#1A Retain House + 3-Unit Backyard Building

TPAG Subcommittee Questions

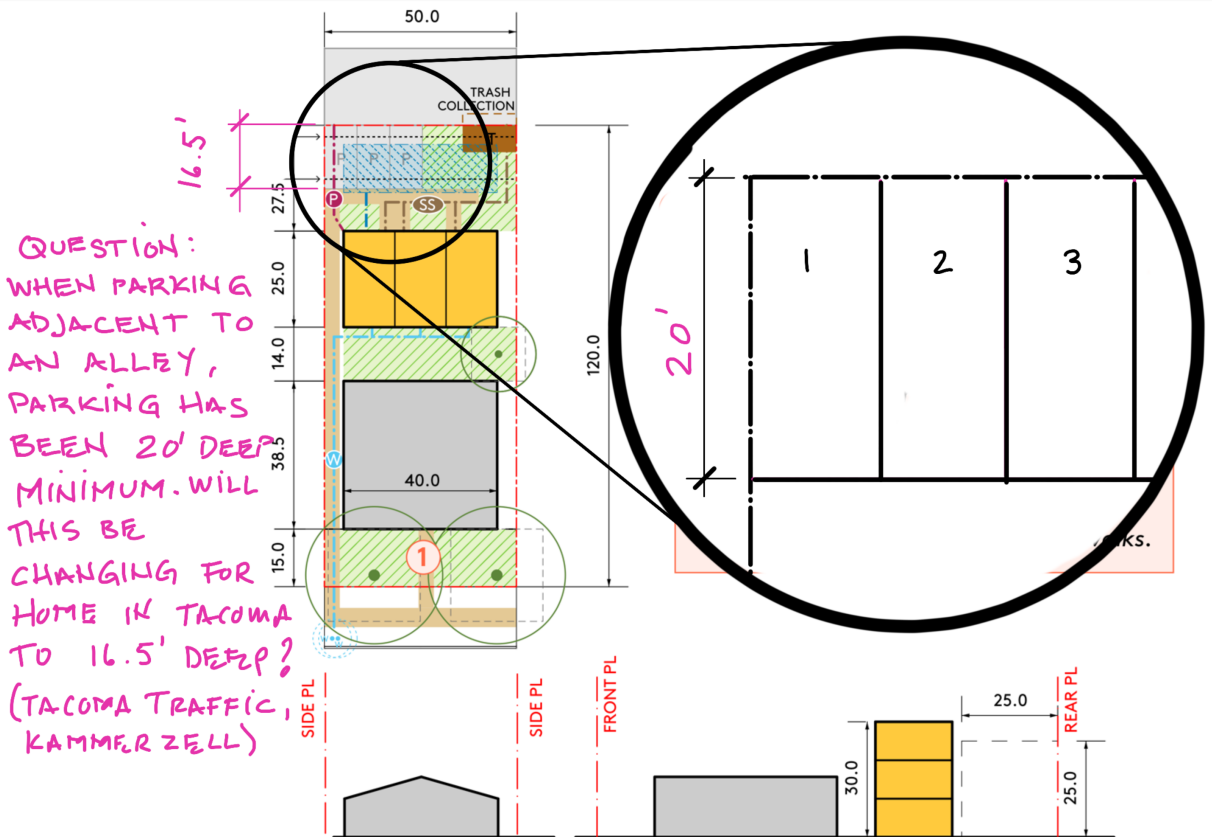
Small existing homes: 1A, 1B, and 1C all picture small existing homes with very specific footprints/positions on the lot. 1C is the worst, as the existing home would need to be about 900 sf and must be positioned about 15' from one property line (to accommodate driveway and power) and 8' away from the other property line (for pedestrian egress). What proportion of existing homes fit these parameters? My guess is less than 5%--probably much less.

Forgotten sewer: 1A, 1B, and 1C don't show sewer from the existing home. How would this affect the drawings? In 1A, I believe it would wipe out a tree.

#1B Retain House + 3-Unit Backyard Building

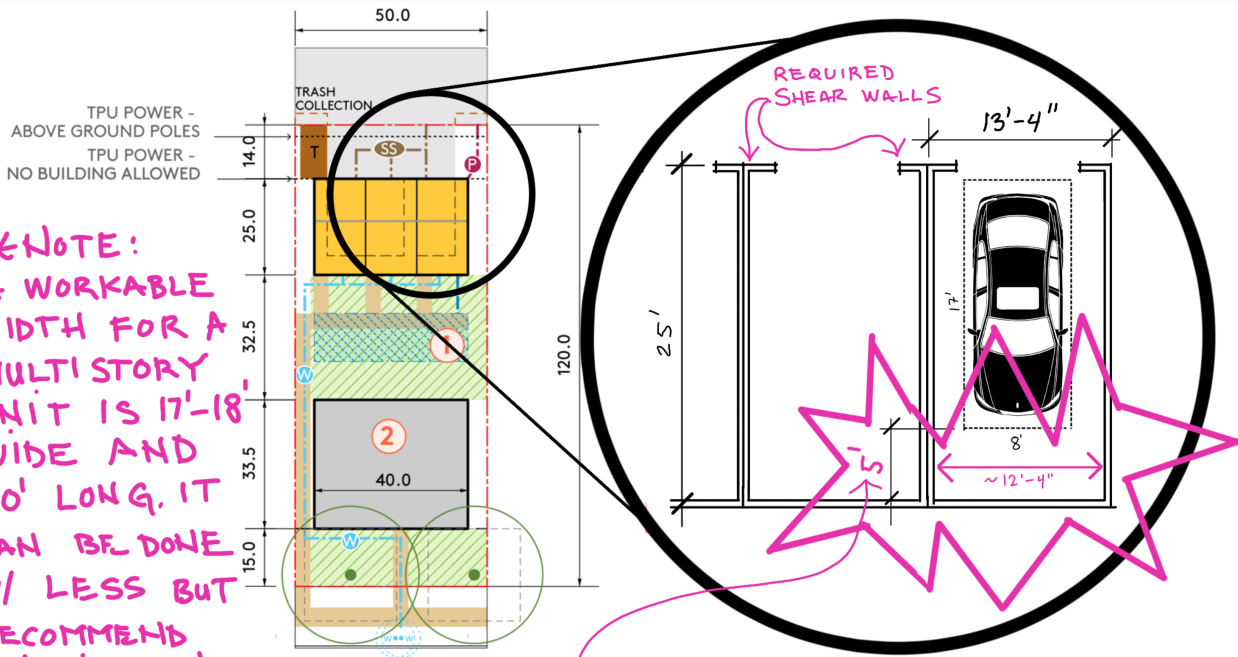
***NOTE:**
A WORKABLE
WIDTH FOR A
MULTI STORY
UNIT IS 17'-18'
WIDE AND
30' LONG. IT
CAN BE DONE
W/ LESS BUT
RECOMMEND
BUILDING IN
SOME FLEXIBILITY

13' wide garage townhomes: 1B and 1C show 13'x30' units with a parking stall and "in-unit bike parking." Is it feasible to package a parking stall, bike parking, and a staircase (out of the garage up to 1st floor) all within a 13'x30' area?

#3A 6-unit Houseplex (Deep Townhouses)

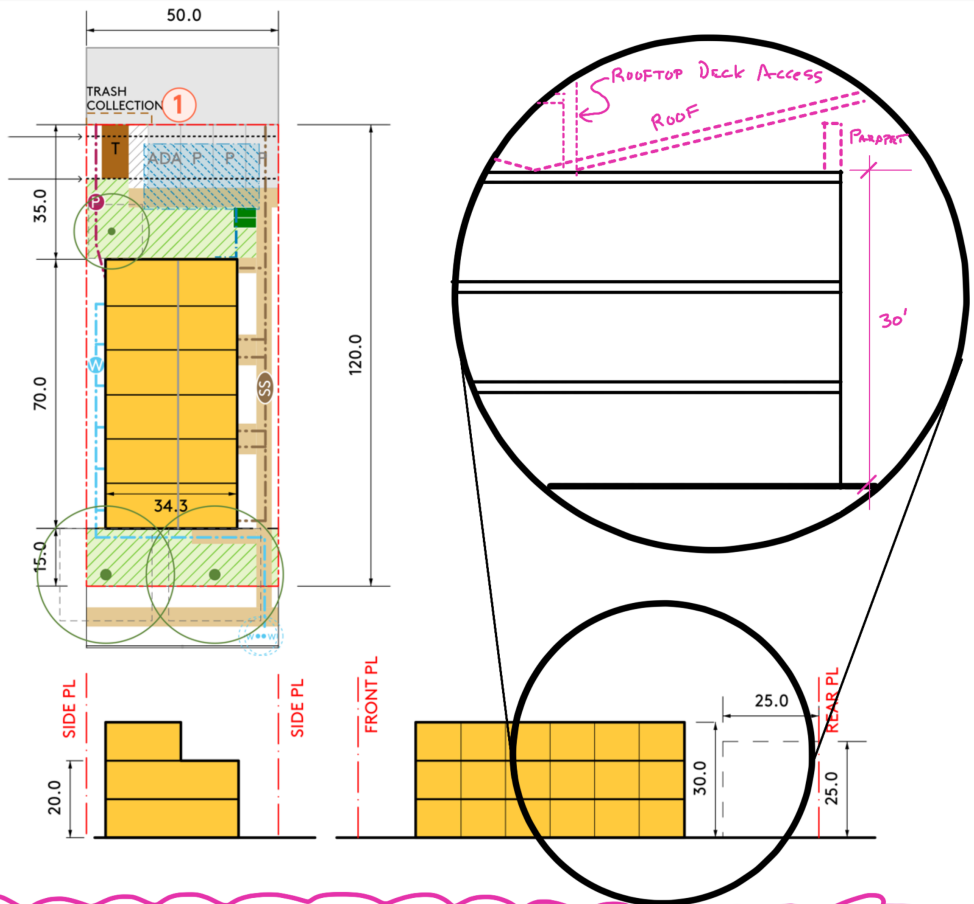
30' building heights: All buildings are shown to be 30' tall. Can rooftop features extend above the 30' height?

Rooftop amenity space: Does a rooftop deck count as a story under the IRC due to roof above access stairway?
